This Service Information bulletin supersedes SI B24 01 08 **dated March 2008**.

E65, E66 with 6HP26 - Diagnosis for EGS FC 4F81

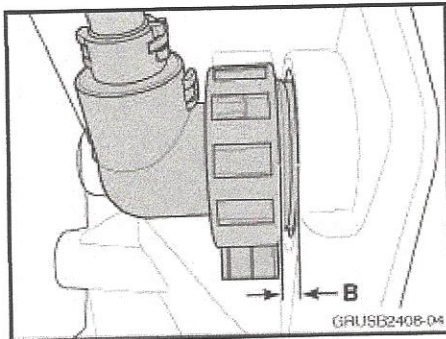
- 4. In case the Mechatronic adapter seal (rectangular) (1) is found to be defective (cracks, seal damage, etc.), replace it with the new part (P/N 24 34 7 588 727).
- 5. Reinstall the Mechatronic and an oil pan, using a new oil pan gasket (P/N 24 11 7 520 712) and the new Mechatronic sealing sleeve (round), P/N 24 34 7 519 357.
- 6. Fill and adjust the transmission fluid, using the previously-saved Shell M-1375.4 (P/N 83 22 0 142 516). For the filling procedure, refer to TIS RA 00 11 500.
